Staff Report & Recommendation

Historic Preservation Board

HPB17-0177, 1116 Ocean Drive.

The applicant, VMSB, LLC, is requesting a Certificate of Appropriateness for the installation of canopy structures with retractable fabric at the ground and roof

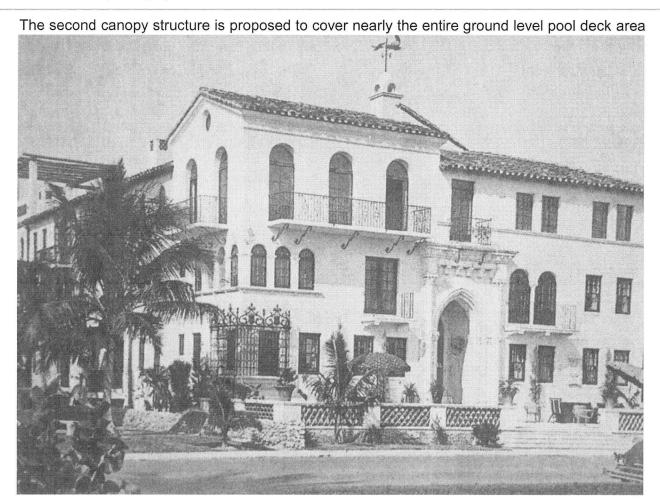
The applicant is requesting approval for the design of two separate retractable canopy structures. The first structure is proposed to be installed at the roof level above the open courtyard within the Contributing building located at 1116 Ocean Drive. Staff has met with the project architect on several occasions and initially expressed concern relative the potential visibility of this structure as viewed from Lummus Park as well as possible impacts on the structural integrity of the existing building. As currently designed however, staff does not believe the retractable canopy will have any adverse impact on the existing building or surrounding historic district and could be easily removed in the future. While supportive of the introduction of a retractable canopy in this location, staff has a concern with the lack of restorative work proposed for the existing historic structure on the site. At a minimum, staff would recommend that the existing tall metal screening and inappropriate dense landscape material located along Ocean Drive be removed and that the original coral rock low wall and decorative balustrade be restored in a manner consistent with historical documentation as shown in the photograph below.

- a. The canopy structure proposed to be located at the ground level within the pool deck area shall not be permitted.
- b. The tall metal screen and dense landscape material located along Ocean Drive shall be removed and the original coral rock low wall and decorative balustrade shall be restored in accordance with available historical documentation, in a manner to be reviewed and approved by staff consistent with the Certificate of Appropriateness Criteria and/or the directions from the Board.
